**Final  
Supplemental Remedial Investigation/Feasibility Study  
Work Plan Addendum**

**For the  
Magna Metals Site  
Lightron Corporation**

**Town of Cortlandt  
Westchester County, New York**

RE: Magna Metals, Site No. 360003  
Remedial Investigation/Feasibility Study Work Plan Addendum

## MAGNA METALS. SITE SKETCH

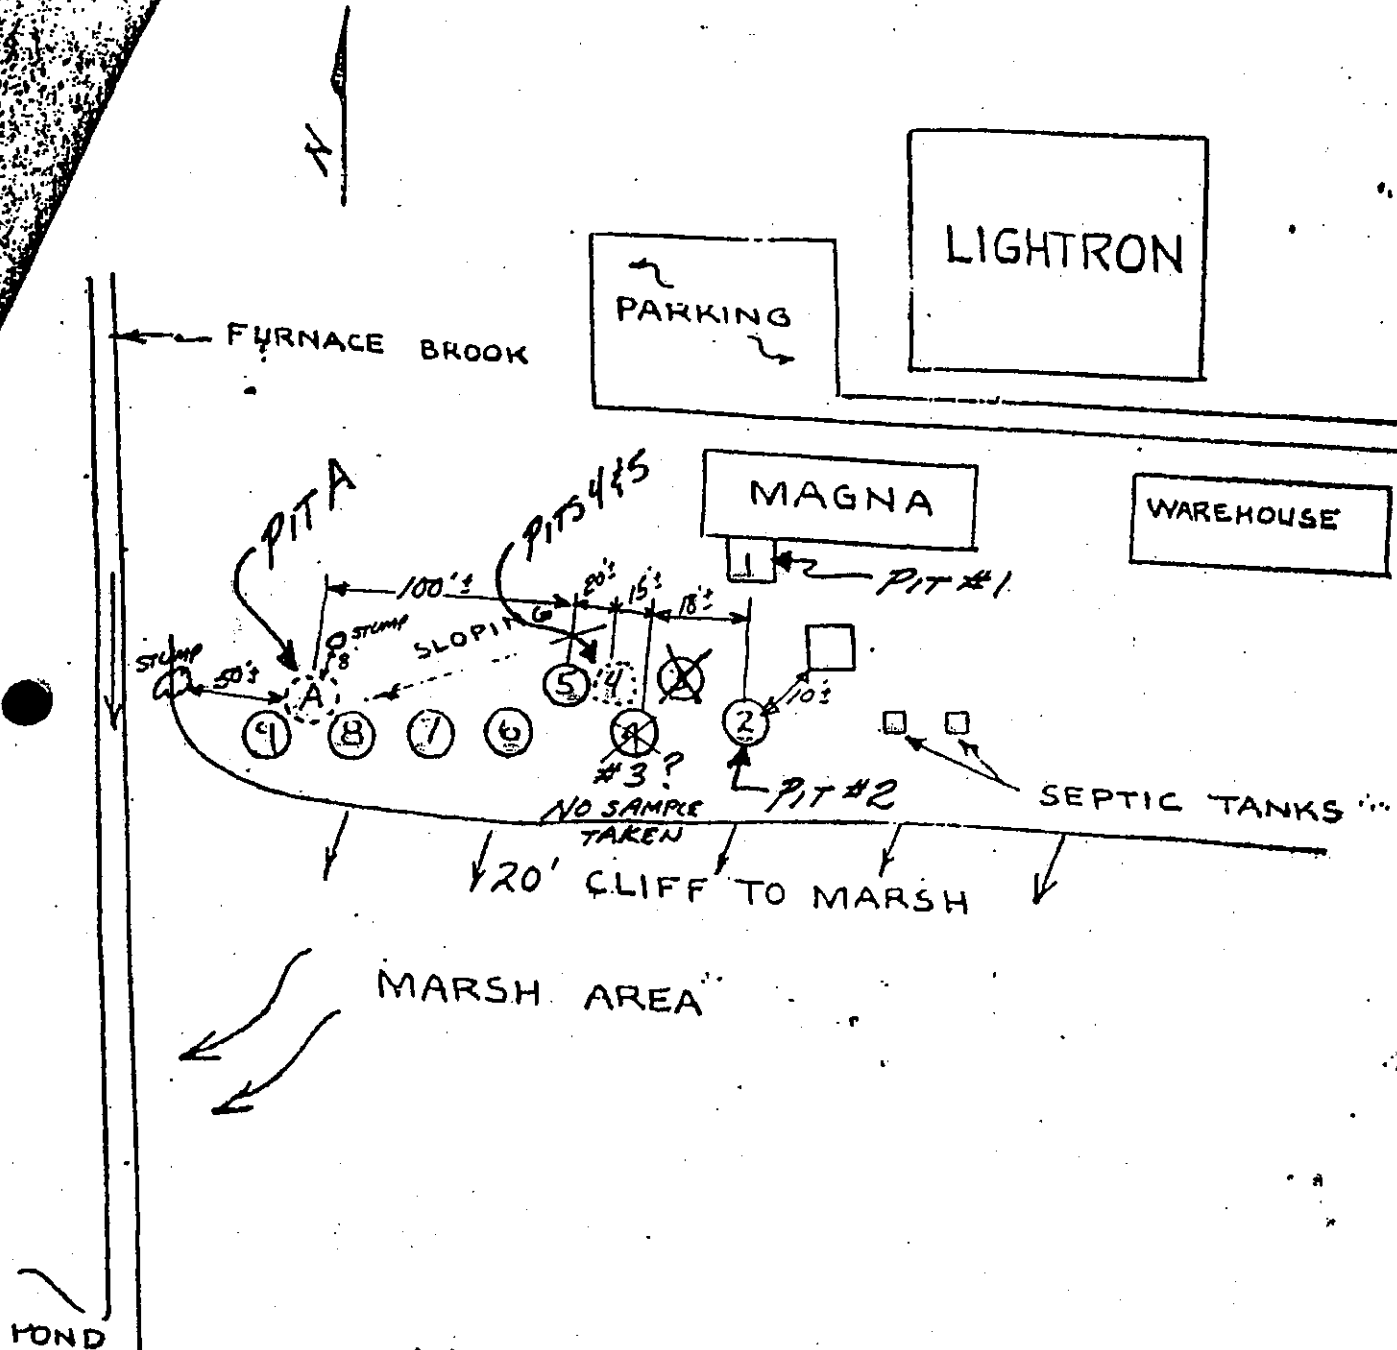
1. The area shown on Figure 1 depicting where geophysical work is to be done is not large enough. One of the figures contained in my letter to you dated September 6, 2002 shows a pit 155 feet to the west of the building. The area shown on Figure 1 does not extend that far. Another figure in the September letter shows a pit northwest of the building. These areas need to be investigated. The refuse area 100 feet west of the building shown in one of the figures in the September letter also needs to be investigated.

A more comprehensive pit location survey will be performed, extending further west than previously performed, based on additional historical NYSDEC documentation.

The search for additional pits and potential refuse area shall extend further to the west than previously investigated and the approximate area for additional geophysical investigation is denoted on Figure 1 (oversize drawing). Based on the NYSDEC maps (Attachment B), the geophysical search will extend approximately 165 feet west of the building. According to NYSDEC figures, the furthest pit is approximately 155 feet from the building. The potential refuse area was shown to be 100 feet west of the building. The geophysical work and associated vegetative clearing will be done in two steps to potentially minimize the amount of trees and small vegetation to be removed. The two step process is shown on Figure 1. Following vegetation removal in Step 1, real time hand-held geophysics will be performed on the cleared area. If the pits and refuse areas are not visually identifiable or detectable using real time, hand-held geophysics, additional vegetative clearance will be performed in Step 2 to widen the investigation area.
